Well Name: BURCH KEELY UNIT	Well Location: T17S / R30E / SEC 18 / SESE /	County or Parish/State: EDDY / NM
Well Number: 27	Type of Well: OIL WELL	Allottee or Tribe Name:
Lease Number: NMLC028793A	Unit or CA Name: BURCH KEELY UNIT	Unit or CA Number: NMNM88525X
US Well Number: 3001504189	Well Status: Producing Oil Well	Operator: SPUR ENERGY PARTNERS LLC

Notice of Intent

Type of Action: Plug and Abandonment

Burch Keely Unit #027 P&A Procedure

P&A Procedure

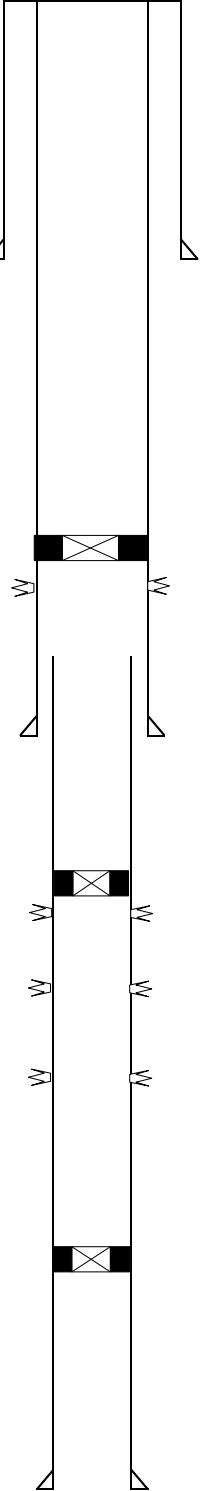
Run Gauge ring to tag CIBP at 3807' and spot 25 sxs on top. WOC and Tag.

1. Set 7" CIBP @3090'. Spot 26 sx of Class C from 3090'-2990'. WOC & Tag.
2940'
2. ~~Spot 75 sx of Class C cmt from 2785'-2635'. WOC & Tag. (9-5/8" Shoe, Top of 7" cutoff)~~
Perf and Squeeze (In 16 sxs/Out 12 sxs) Spot cement from 2685' to 2608'. (26 sxs Class C) WOC and Tag.
2780' to 2685'.
3. Set 9-5/8" CIBP @ 2421'. Pressure test casing to 500 psi for 30 minutes. Run CBL from 2421'-surface.
Spot 50 sx of Class C cmt from 2421'-2321'. WOC & Tag Perf and squeeze from 1175' to 944'. WOC and Tag. (In 76
25 2345' sxs/Out 55 sxs)
4. Perf @ 410' and sqz 60-sx of cmt from 410'-310'. WOC & Tag. (13-3/8" Shoe)
544' (In 179 sxs/Out 147 sxs) 544' to surface. Verify at surface.
5. ~~Spot 50 sx of Class C cmt from 100'-surface. (surface plug)-~~
6. Verify cmt to surface on all annuli. Cutoff Wellhead. Weld on Below Ground Dryhole Marker.

If solid base no need to Tag (CIBP present and/or Mechanical Integrity Test), If Perf & Sqz then Tag, Leak Test all CIBP if no Open Perforations			
San Andres @ 2730	2652.70	2780.00	127.30	ns	54.00	C	Perf and squeeze from 2780' to 2685. WOC and Tag. (In 16 sxs/Out 12 sxs) Spot cement from 2685' to 2608'. 26 sxs WOC and Tag.
				If solid base no need to Tag (CIBP present and/or Mechanical Integrity Test), If Perf & Sqz then Tag, Leak Test all CIBP if no Open Perforations			
CIBP Plug	3055.00	3090.00	35.00	ns	25.00	C	Set 7" CIBP at 3090'. Spot cement from top of CIBP to 2940'. WOC and Tag.
Perforations Plug (If No CIBP)	3090.00	3623.00	533.00	Tag/Verify			
				If solid base no need to Tag (CIBP present and/or Mechanical Integrity Test), If Perf & Sqz then Tag, Leak Test all CIBP if no Open Perforations			
CIBP Plug	3772.00	3807.00	35.00	ns	25.00	C	Run Gauge ring to Tag CIBP at 3807' and spot 25 sxs on top. WOC and Tag.
